COMMENTS ON THE
DRAFT ENVIRONMENTAL IMPACT STATEMENT AND
DRAFT SECTION 4(f) EVALUATION FOR
WASHINGTON UNION STATION EXPANSION PROJECT
(DEIS 20200120)

AKRIDGE

SEPTEMBER 28, 2020

Image submitted on August 22, 2017 in the document titled "Analysis of Preliminary Alternative Impacts on BP"

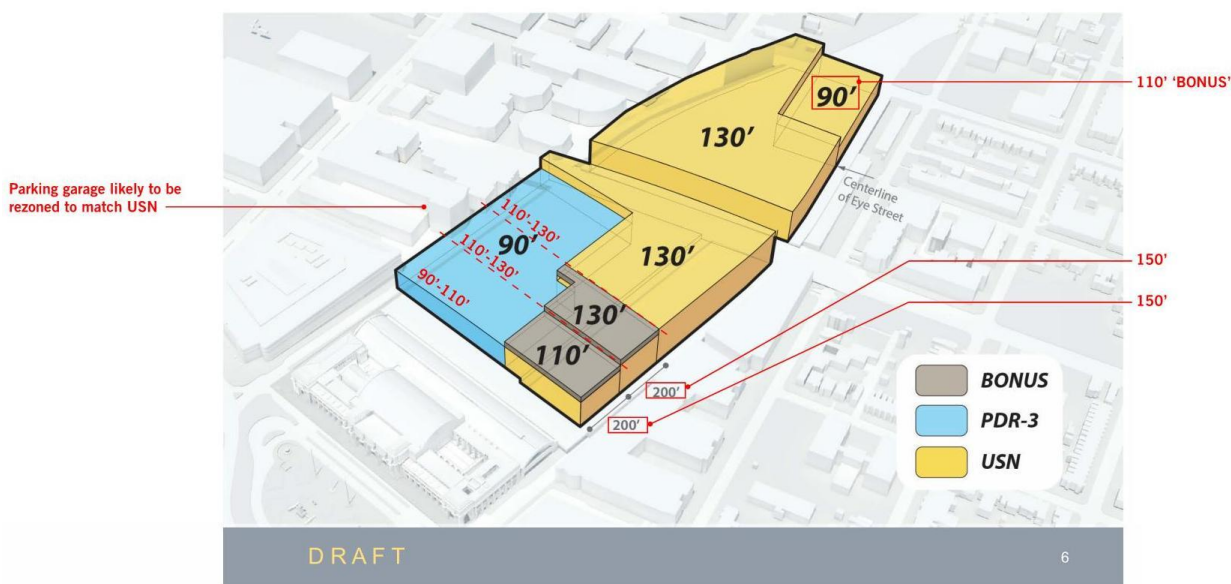
Appendix A5b, Section A-2.6 of the DEIS includes a zoning envelope diagram that contains inaccuracies regarding zoning permitted heights and setbacks from the south end of the Union Station North (USN) zone boundary line. The DEIS diagram describes a graduated height increase from that south boundary line as you move north along the centerline of the historic station in 200' plan increments. The USN zoning regulations (DCMR Title 11, Subtitle K, Section 305.1) specifies a 150' increment. The north-east corner of the USN zone district is similar to the far south bonus. USN zoning allows a 90' building height, with a height bonus to 110' permitted through design review and approval from the DC Zoning Commission.

Figure 1: DEIS Proposed PUDO Locations⁵

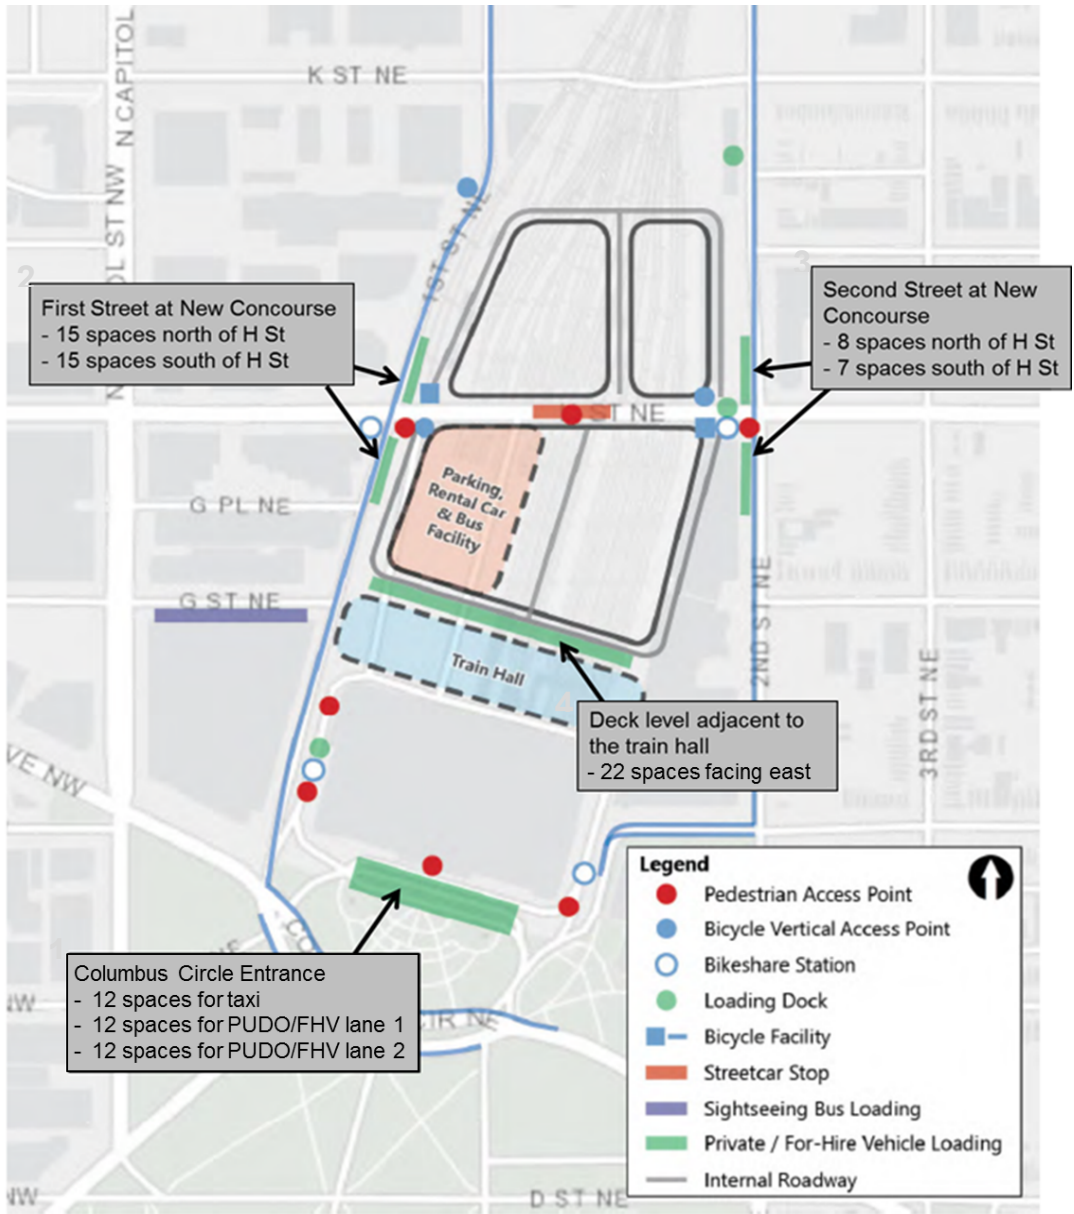
The overall approach to PUDO in the DEIS proposal is to distribute operations at four facilities around WUS. **Figure 1** summarizes the location of the four proposed PUDO facilities along Columbus Circle, 1st Street, 2nd Street, and at the deck level.

Distribution of spaces vs. demand: The four proposed PUDO locations are shown on **Figure 1** and the number of spaces based on information presented in the DEIS and Sam Schwartz assumptions (where detailed information is not provided in the DEIS) are summarized in **Table 1**. As shown in **Table 1**, the number of spaces proposed in the DEIS that would be provided at each PUDO facility does not align with the projected demand for each facility. In some cases, like at the 1st and 2nd Street facilities, providing a greater number of spaces than the percentage of operations expected to use each facility could provide potential benefits, as these facilities are on city streets and additional space for PUDO may reduce the likelihood of double parking or impacts to traffic flow, or reduce the need for active management of those facilities. As seen in **Table 1**, the number of PUDO spaces available at Columbus Circle and the deck level are proportionally lower than the overall number of spaces required per FRA demand allocation. The potential problem is that if the number of spaces provided does not align with demand projections, it may result in issues of queue spillback, especially at Columbus Circle, which is already observed to operate poorly under current conditions.

Figure 2: Concerns with DEIS Proposed PUDO Locations

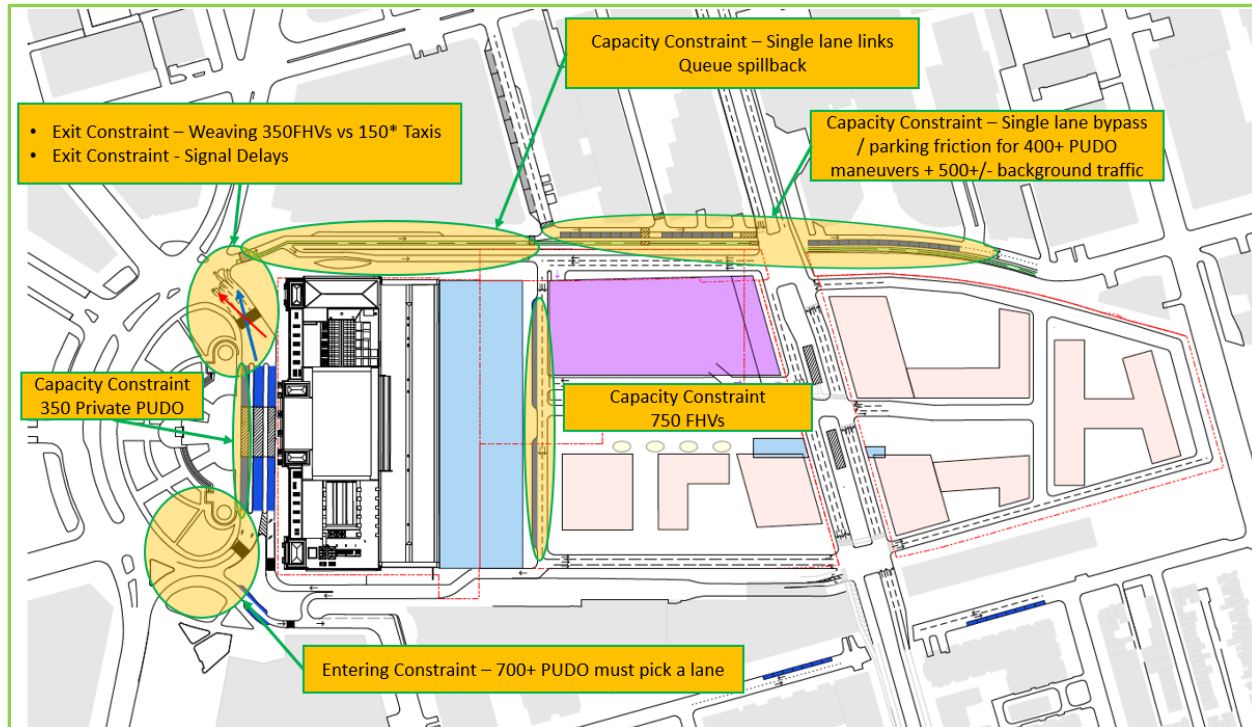
The major concerns with each proposed PUDO location are discussed below and illustrated in Figure 2.

Figure 3: DEIS Proposed Design for Columbus Circle PUDO Facility

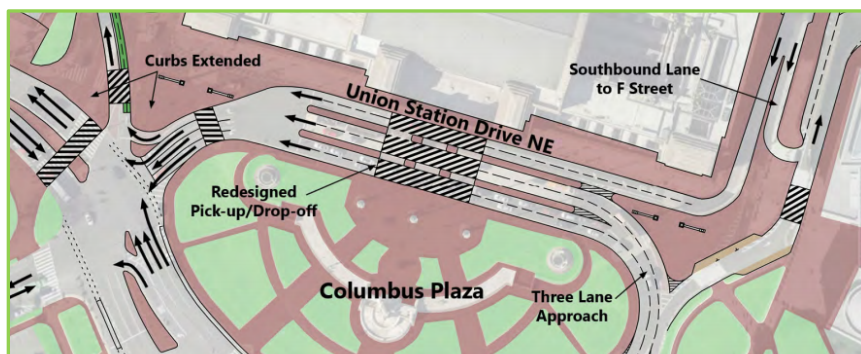
The DEIS design of the Columbus Circle PUDO facility is similar to current conditions, with the exception being that tourist and hop-on/hop-off buses would be removed from the middle two lanes, making the entire Columbus Circle facility available exclusively for PUDO functions. There would continue to be three parallel roads in front of the historic station entrance, each with two travel lanes, as shown on **Figure 3**. FRA provided the following description of operations for the three roads.⁸ The right lane of each road would provide loading and unloading access and the left lane would facilitate passing. The northern roadway (closest to Union Station) would continue to be dedicated for taxis only, and taxis would continue to have separate access from the roadway that wraps around the station from the deck level. While the DEIS describes the taxi area as containing 24 spaces, we estimate that there would only be 12 functional spaces, with two rows of six spaces and each row loading and departing in unison. The remaining two roadways would accommodate PUDO, each with another 12 functional spaces.

Figure 4 illustrates the existing queue of taxis at this location. This queue will also likely block the crosswalk shown in the DEIS plan depicted in **Figure 4**.

Figure 5: DEIS Proposed Design for 1st Street PUDO Facility

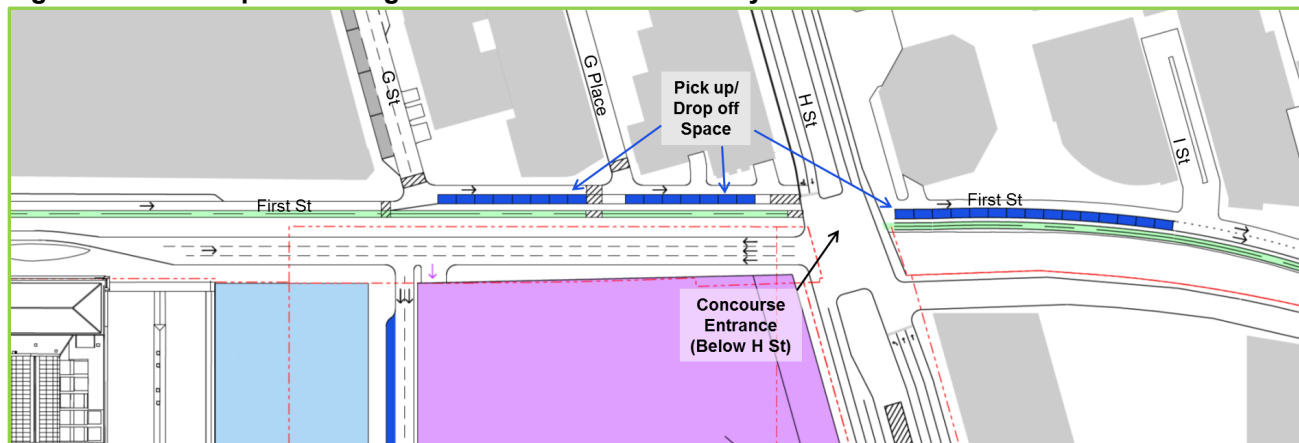
The DEIS design of the 1st Street PUDO facility would create 30 spaces for PUDO operations along the east side of 1st Street near the new H Street Concourse entrance. It is assumed that both pick-up and drop-off activity would be accommodated at this facility. The DEIS design indicates that 1st Street would operate with one northbound travel lane, the PUDO lane, and a cycle track between the PUDO lane and the sidewalk, as shown on **Figure 5**. The PUDO lane and the travel lane both appear to be 11 feet wide. Similar to the description for the Columbus Circle facility, no information is given in the DEIS for how this facility would operate or be configured to meet the variations in use and demand.

- While 30 spaces are provided to service an estimated peak demand of 400+ pick-ups and drop-offs, the single through lane is projected to be constrained by the 400 vehicles looking for a space and maneuvering in/out of these spaces.
- In addition, there are an estimated 500+ vehicles that constitute background traffic not associated with PUDO. The activity of 900+ vehicles would occur on one travel lane past the PUDO spaces. The background traffic may also include a high percentage of buses due to the proposed bus facility on G Street. All this activity will be difficult, at best, to manage with one travel lane.
- The single lane leading from Massachusetts Avenue/Columbus Circle is also projected to experience queues that may reach Columbus Circle during peak periods.

Figure 6: DEIS Proposed Design for 2nd Street PUDO Facility

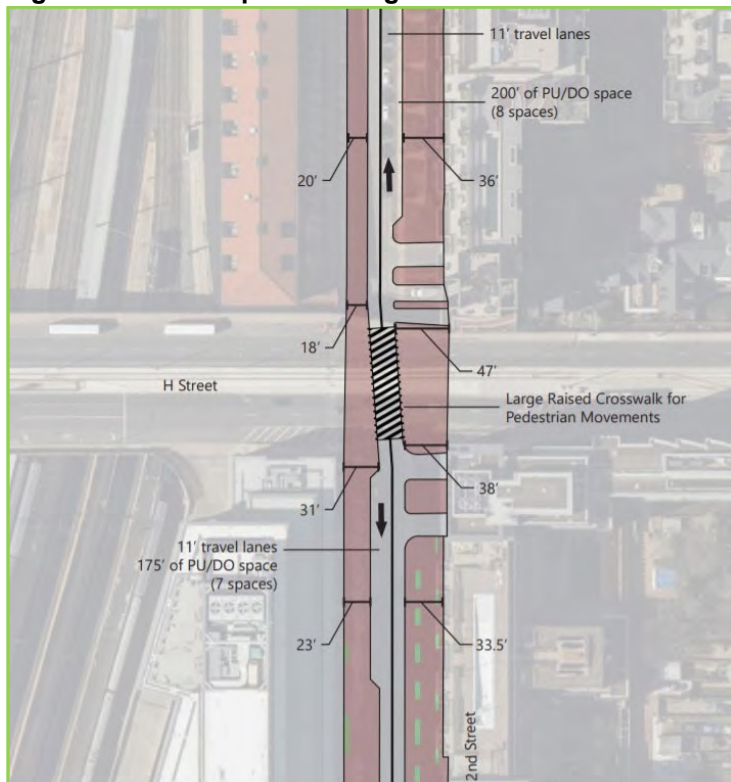
The DEIS design of the 2nd Street PUDO facility would create 15 spaces for PUDO operations along either side of 2nd Street near the new H Street Concourse entrance, as shown on **Figure 6**. 2nd Street would be a two-way street with one 11 foot travel lane in each direction. Seven PUDO spaces would be located on southbound 2nd Street, south of H Street, and eight PUDO spaces would be located on northbound 2nd Street, north of H Street. Each PUDO area was analyzed separately. The PUDO lanes appear to be 8 feet wide. It is assumed that both pick-up and drop-off activity would be accommodated at this facility.

The number of spaces provided, along with the low volumes estimated to use this PUDO location and relatively low background volumes do not appear to cause a concern at this location.

Figure 7: DEIS Proposed Design for Deck-Level PUDO Facility

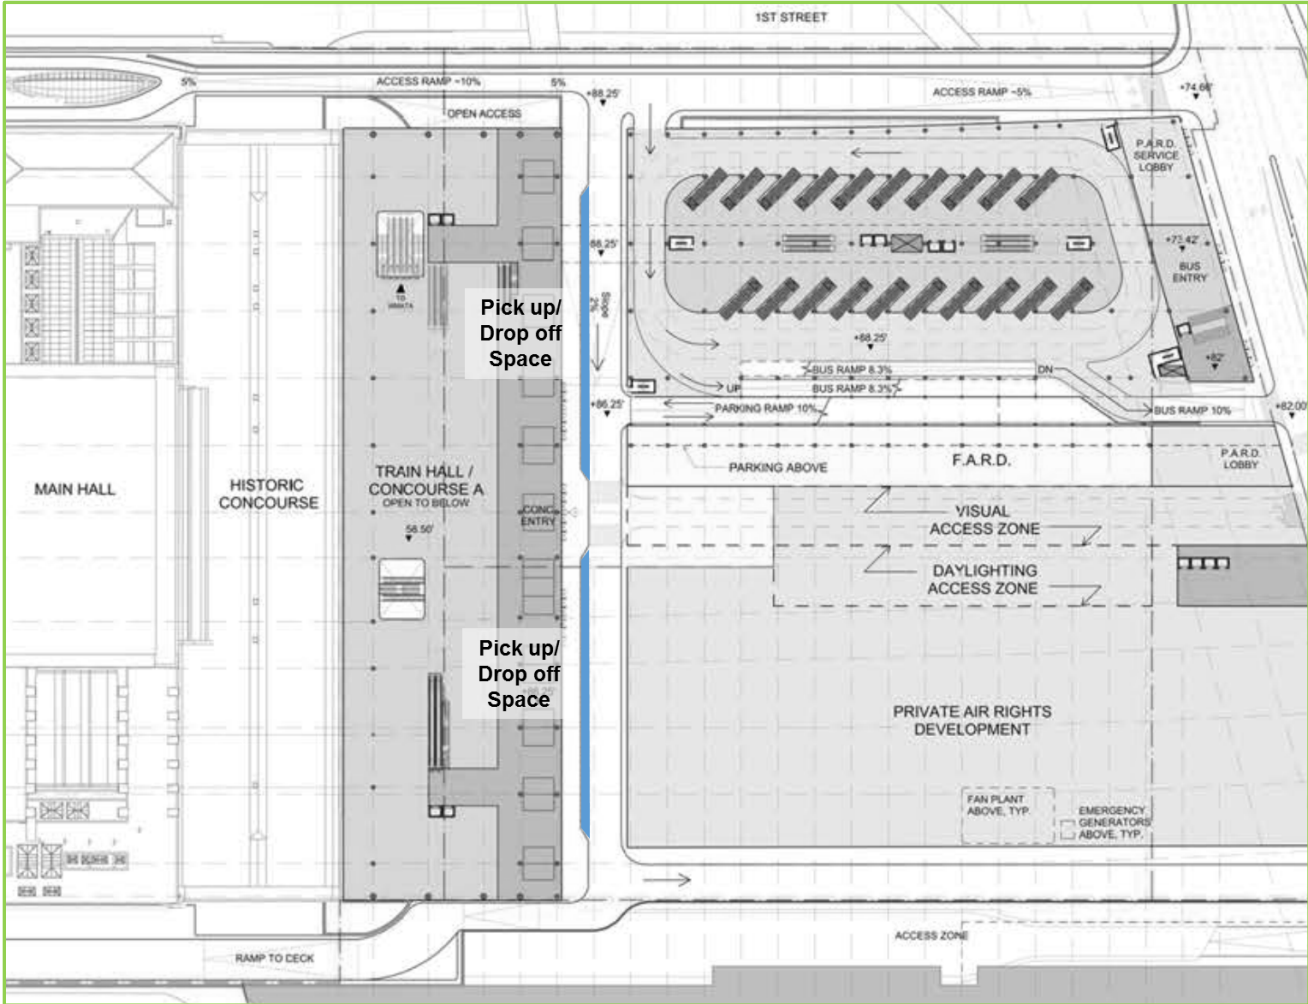
The DEIS does not provide details about the design of the deck-level PUDO facility at the Train Hall, shown in **Figure 7**; however, our analysis is based on a review of the DEIS circulation plan and drawings. The 428 feet length of curb space shown in the DEIS drawings shows that this facility would have a capacity of approximately 17 curbside spaces for PUDO operations.

intersection to the Train Hall PUDO as well as spill back towards H Street and down the ramp towards Columbus Circle. Under the DEIS plan, this deck-level road is also assumed to continue to be used as taxi staging/queuing for the Columbus Circle taxi stand. These queues will restrict the exiting capacity of the PUDO operations. Some of these issues could perhaps be addressed by the addition of more traffic lanes in front of the Train Hall, but this solution is not illustrated in the DEIS and would have significant impacts on Burnham Place and pedestrian access to the Train Hall.

Exhibit 2
Intersection Configuration at West Road/East-West Road

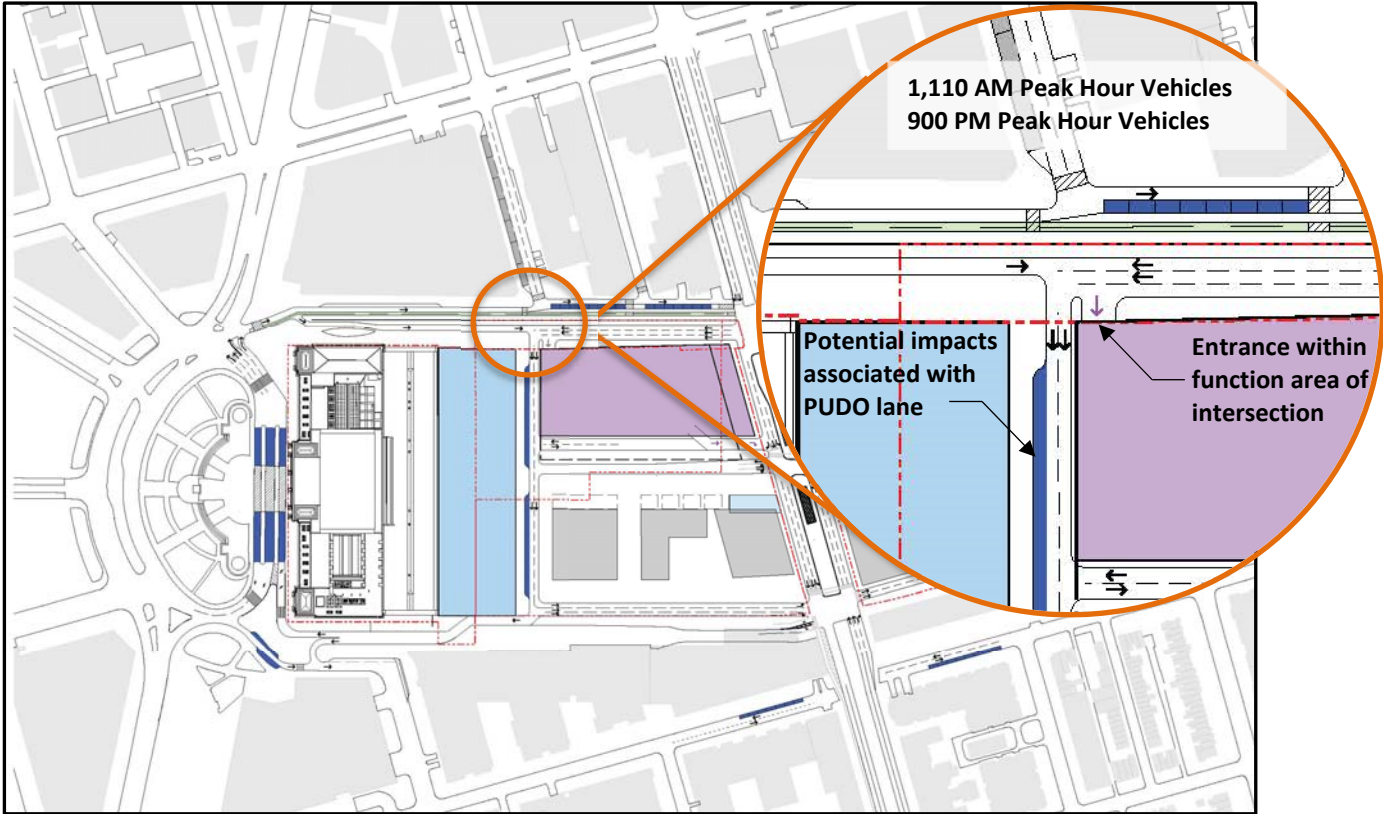
Exhibit 2 shows the layout of the intersection and highlights the areas of concern.
